CR and C2M host channel model parameters

Comments #92, #83

Adee Ran, Cisco

Figure 178A–2—Transmitter S-parameter model

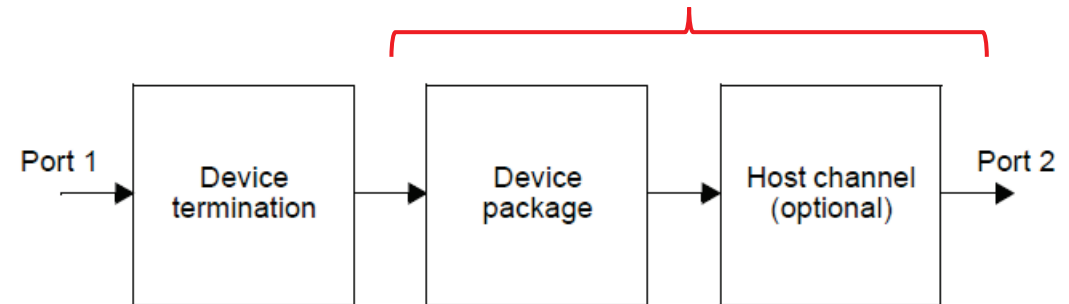
Should be
18.95

CR Host class	Max ILdd (TP0d-TP1 or TP4-TP5d)
HL	12.75-9.75= 3
HN	17.75-9.75= 8
HH	22.75-9.75= 13

Figure 176D-6—Reference insertion loss budget at 53.125 GHz

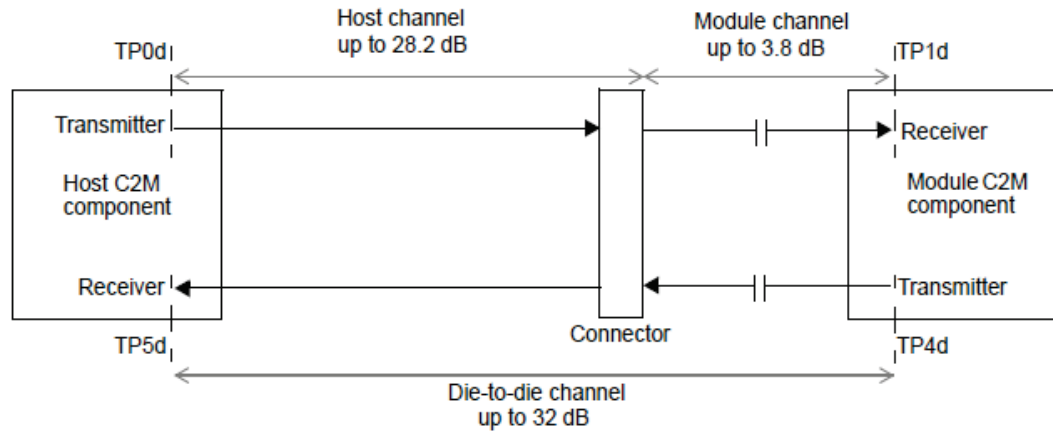
The response to comment #115 included the statements:
“Based on the straw polls, there is consensus to use 32 dB as the TP0d to TP1a budget.
Per ghiasi_3dj_03a_2409, the module ILdd allocation is 3.8 dB, same as the HCB.
Therefore, TP0d to TP1d is also 32 dB.”

C2M Host class	Max ILdd (TP0d-TP1d or TP4d-TP5d)
(there is only one)	$32 - 9.75 = 22.25$

Proposed CR host channel parameter values

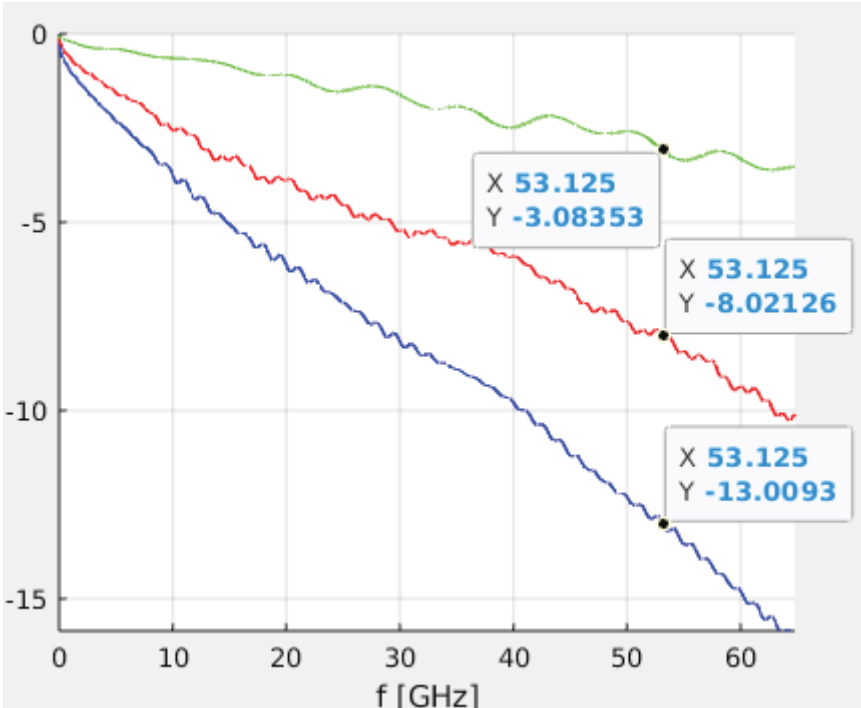
(comment #92)

Updated Table 179-18

Resulting ILdd [dB]	3	8	13
---------------------	---	---	----

Parameter	Host class			Units
	HL	HN	HH	
Package class	A	B	B	—
Package transmission line 1 length, $z_p^{(1)}$	8	15	45	mm
Host transmitter or receiver transmission line length, $z_p^{(h)}$	9	70	60	mm

(No “Test 1 / 2”)

Proposed C2M host channel parameter values (comment #83)

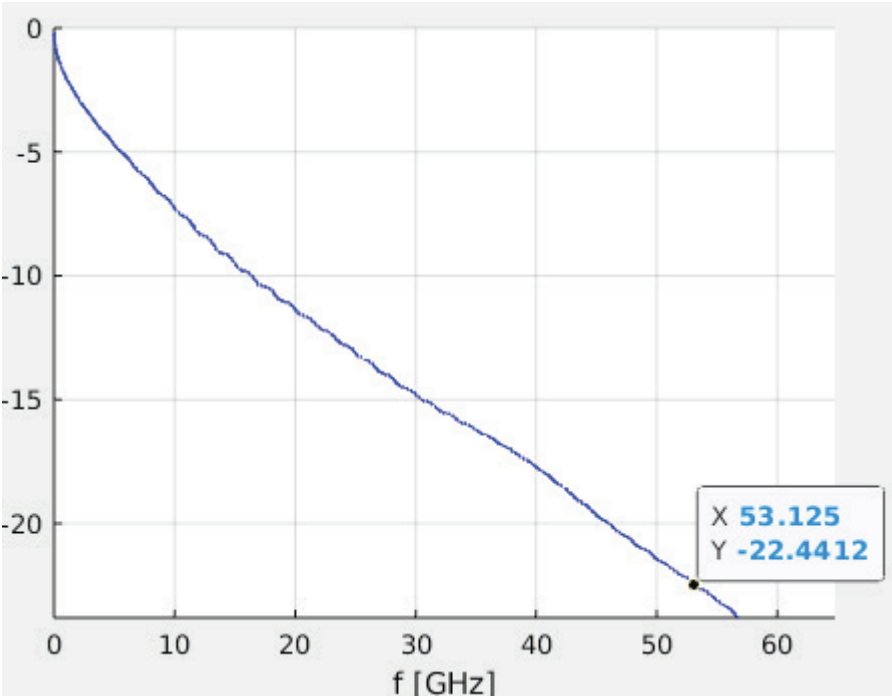
Change Table 176D–5

Resulting ILdd [dB]	22.44
---------------------	-------

Parameter	Value	Units
Package parameters	<i>[Keep class B parameters, delete class A parameters]</i>	—
Package transmission line 1 length, $z_p^{(1)}$	45	mm
Host transmitter or receiver transmission line length, $z_p^{(h)}$	250	mm

(No “Test 1 / 2”)
